RFP CHANGE NO. 1

**RE: Colchester IM 089-3(69)
Construction Manager/General Contractor (CMGC) Project - Request for Proposals**

FILE NAME: z95c208tgnnotes.dgn
 PROJECT LEADER: S.E. BURBANK
 DESIGNED BY: R.H. BARNES
 TRAFFIC PHASING NOTES

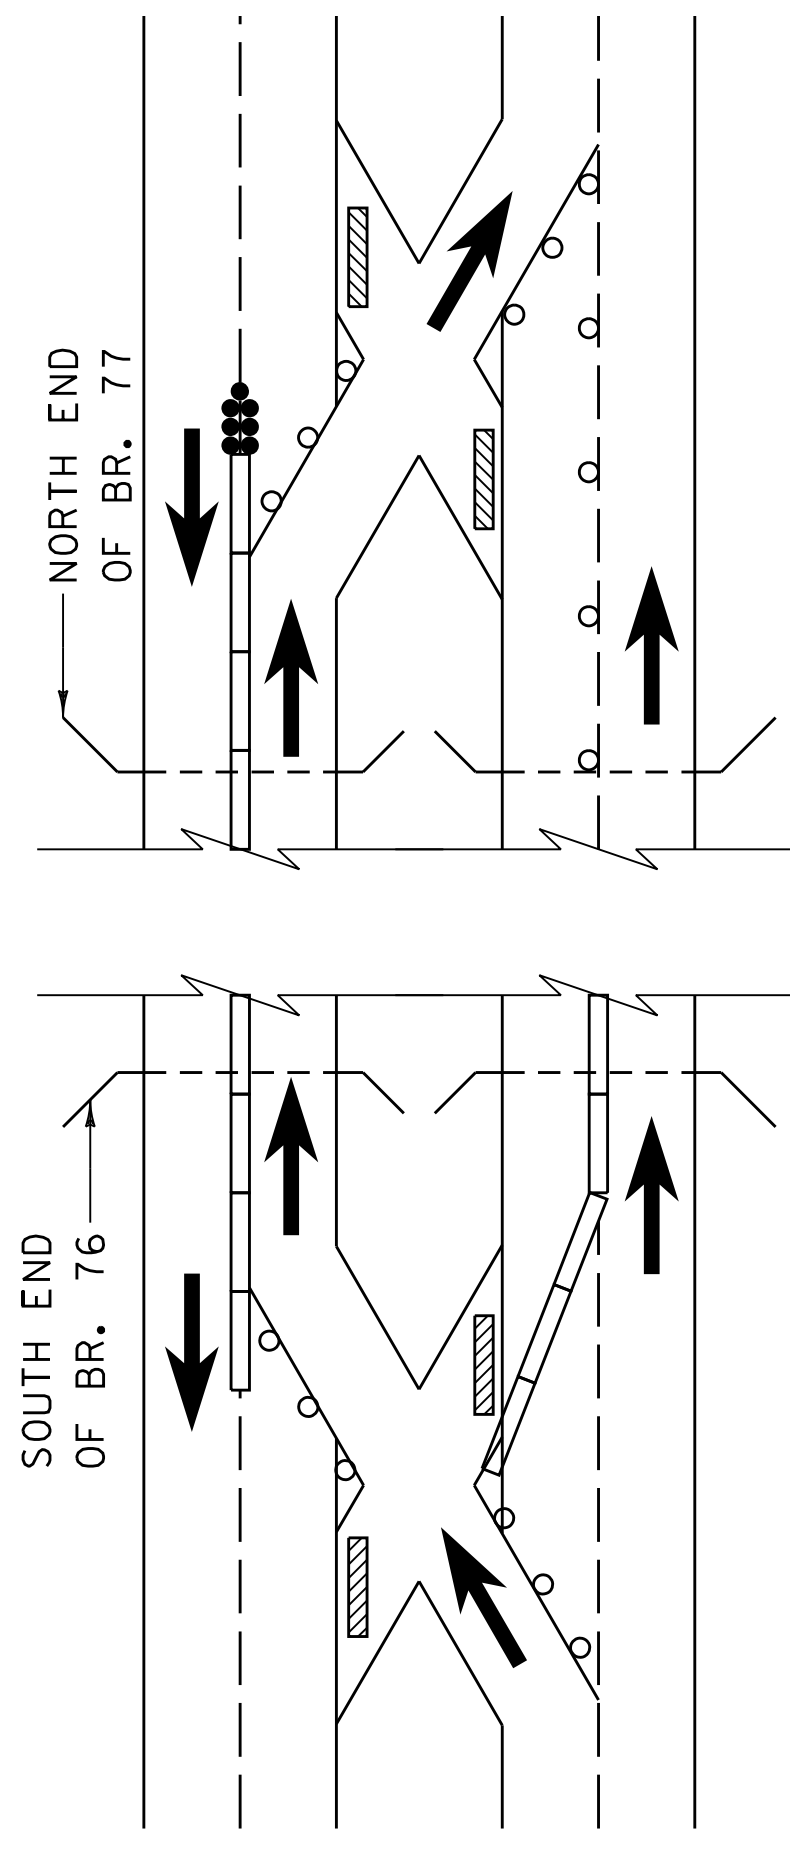
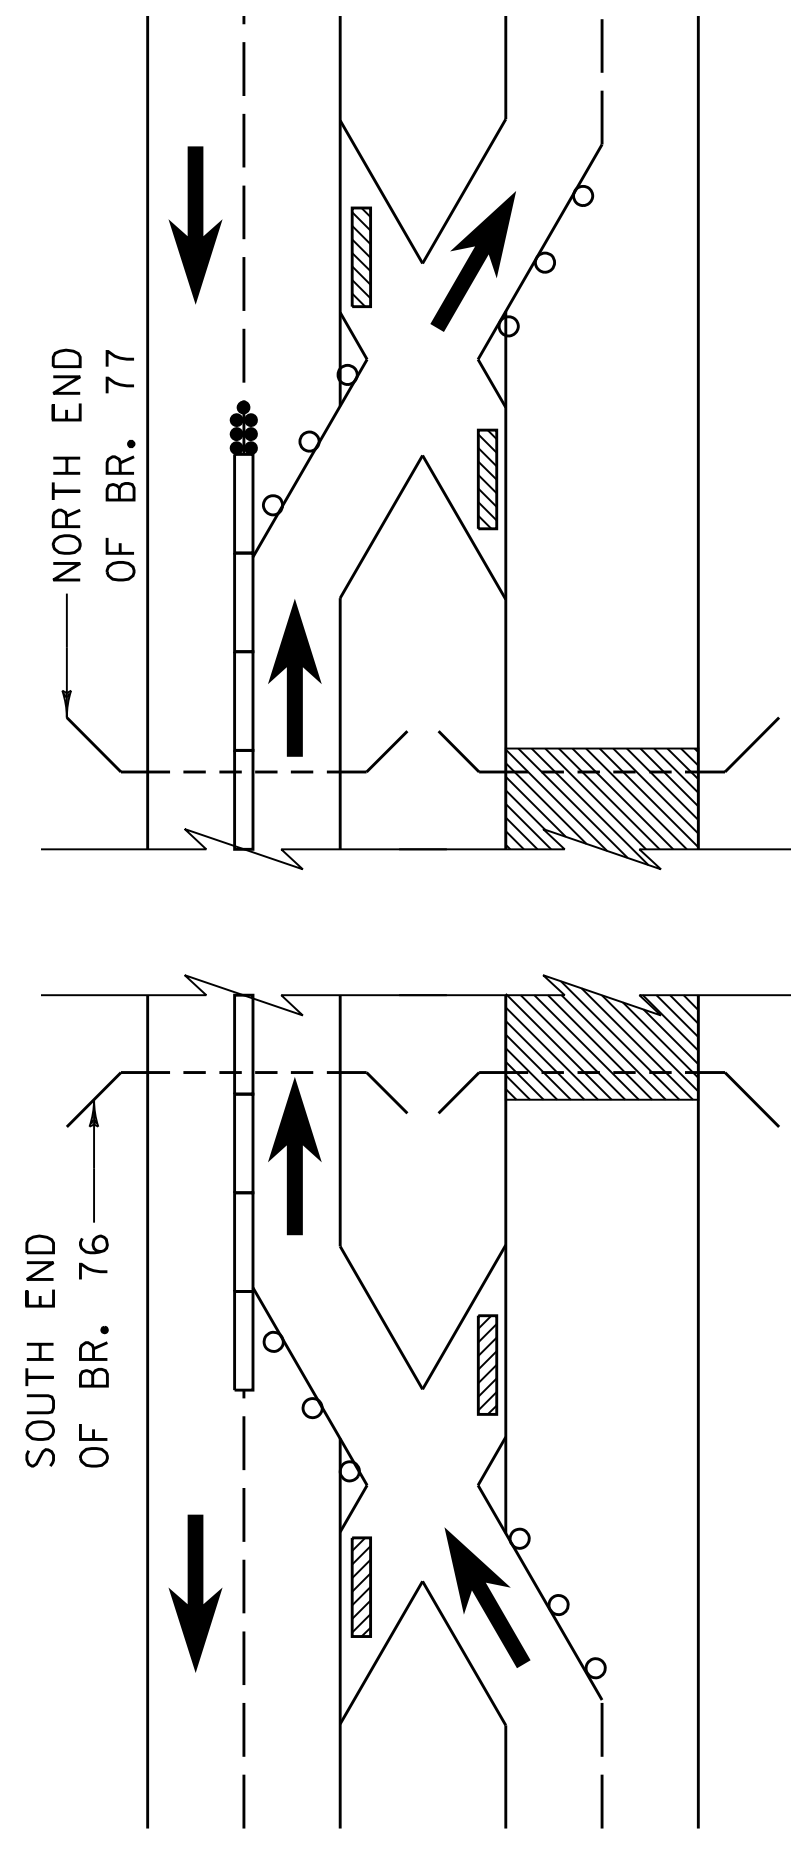
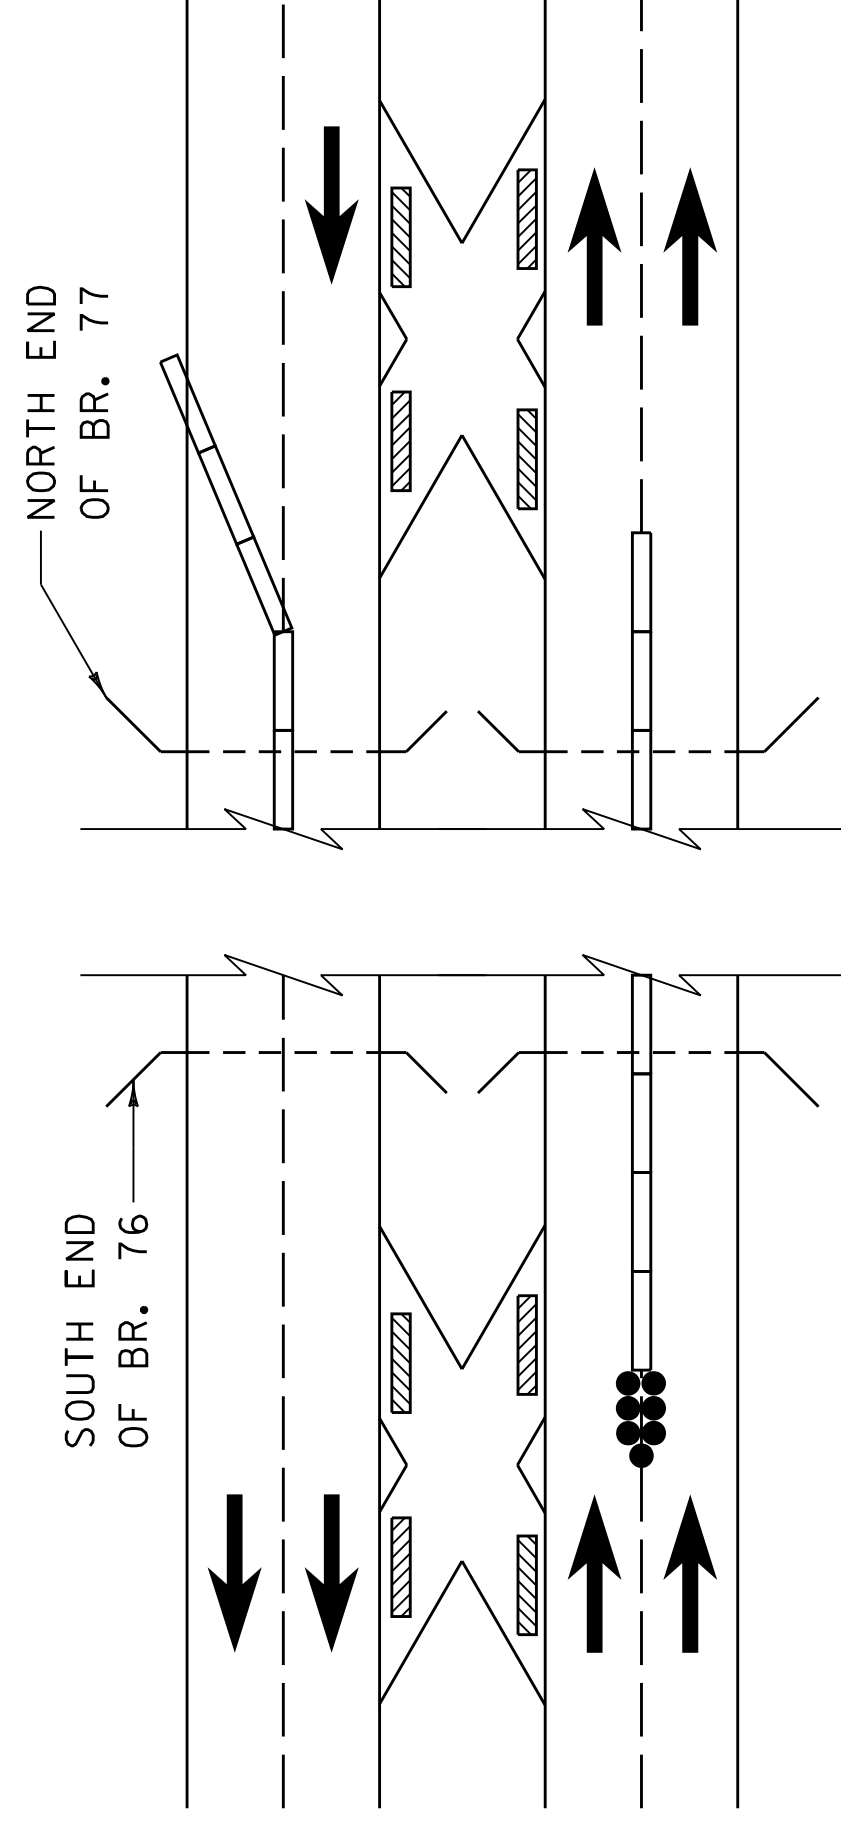
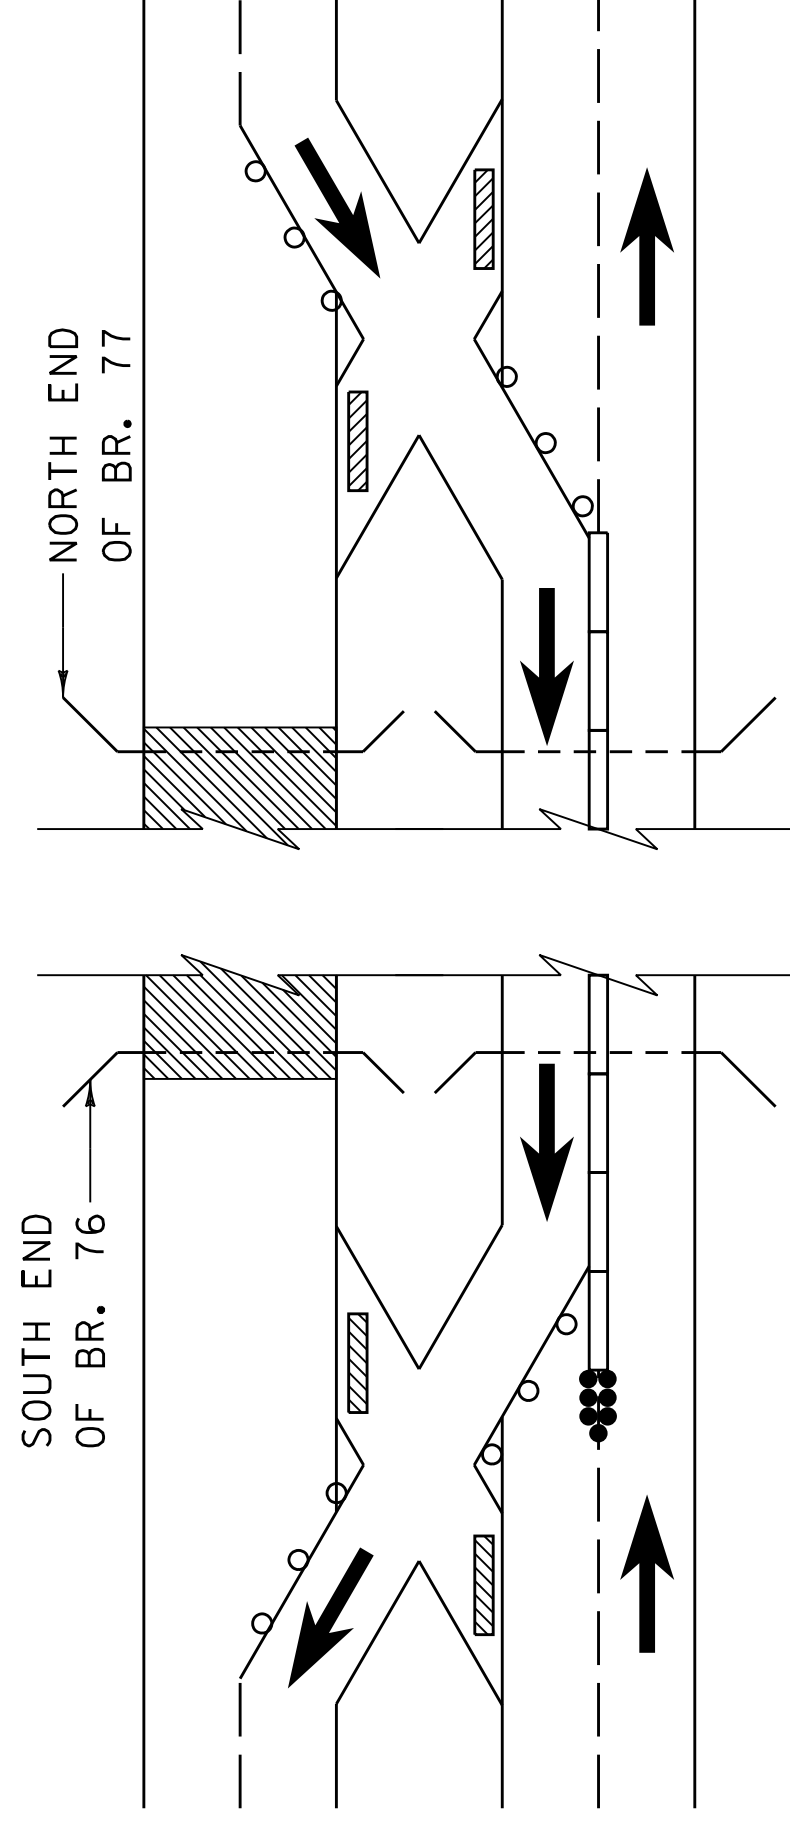
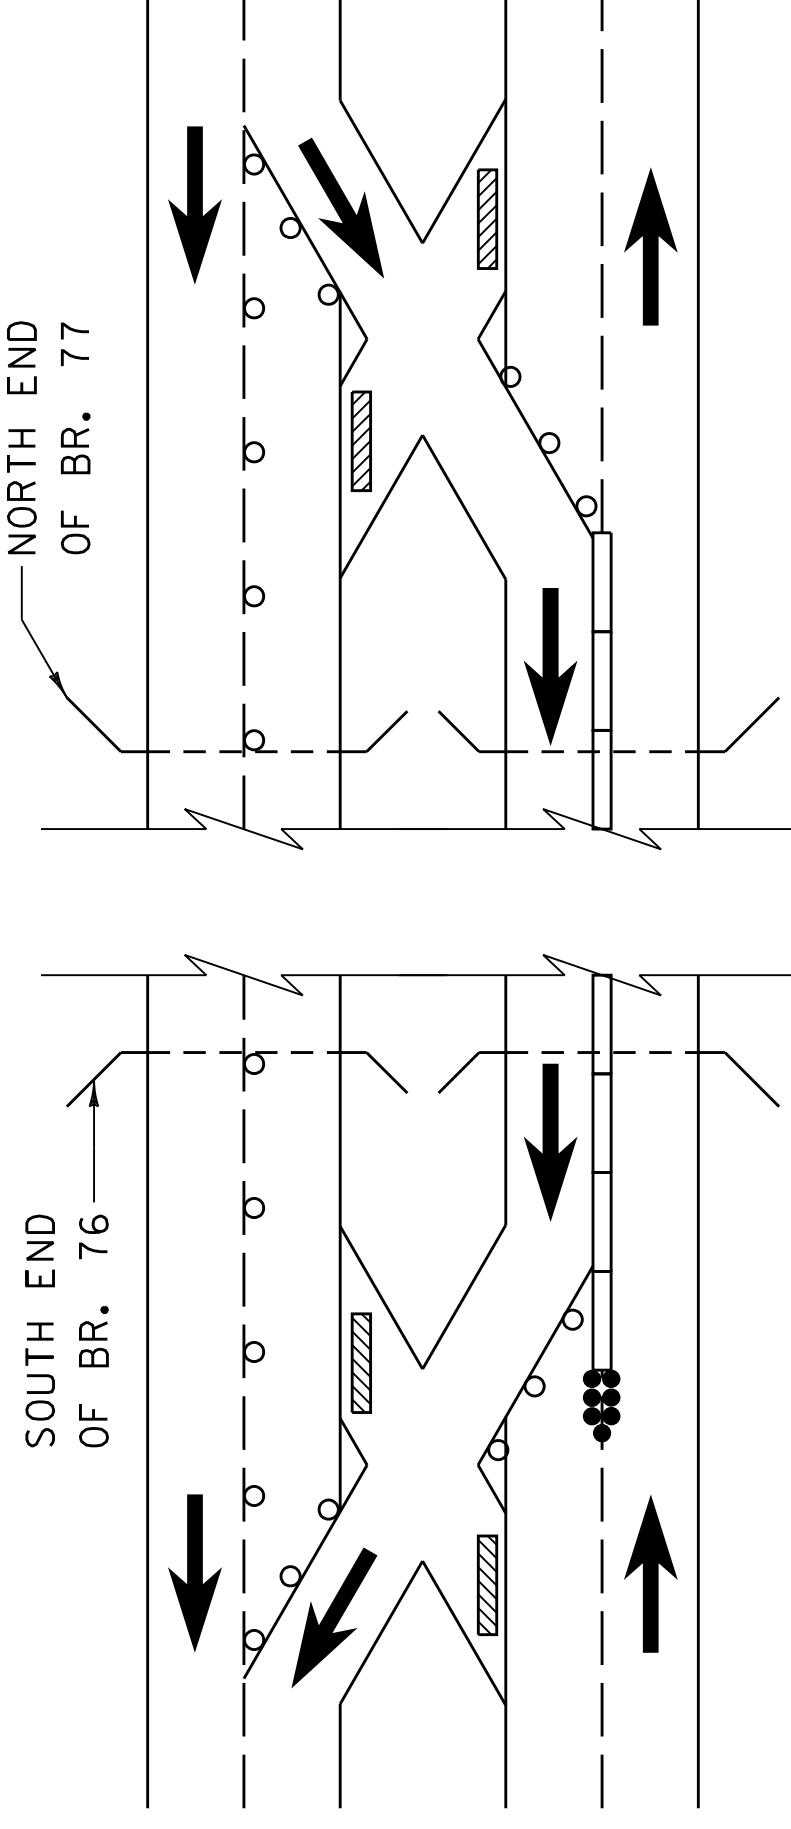
1. **QUESTION:** Under Specification Section 1.2 Key Project Goals & 1.4 Staged Demolition, it is stated that partial deck demolition is allowed starting a maximum of 96 hours prior to the weekend closures. This implies that during this continuous 96 hour period only three lanes of traffic will be open. On sheet 16 of the project plans, NB Phase 1 shows deck demolition starting at 7 pm on Thursday and sheet 19 shows SB Phase 1 deck demolition starting at 10 am on Friday prior to the weekend shutdown. This allows significantly less than 96 hours for partial deck demolition. Please clarify the significance of the times shown on the Phase drawings and how they relate to the 96 hour shutdown.

2. **QUESTION:** On sheet 15 of the project plans, below the table *2018 Estimated Average Volumes* it is indicated that a hatched area will show when a reduction to one lane is allowed. Also, note one on sheet 15 says that the table will indicate when one lane is allowed. There are no hatched areas within the table and no other indication on the table when reduction to one lane is allowed. Please clarify when reduction to one lane is allowed.

ANSWER: Per the RFP, the partial deck demolition can start a maximum of 96 hours prior to the weekend closures, including providing three lanes of traffic when required. The plans depict partial deck demolition times of a lesser duration to indicate the intended typical traffic patterns in the days prior to closure. Note that in the time of partial deck demolition prior to the closure, traffic patterns will need to be maintained as indicated in the plans, including providing two (2) travel lanes in the direction and times indicated.

ANSWER: See provided revised sheet 15 for the hatched areas. This revised sheet is attached to the back of this RFP Change.
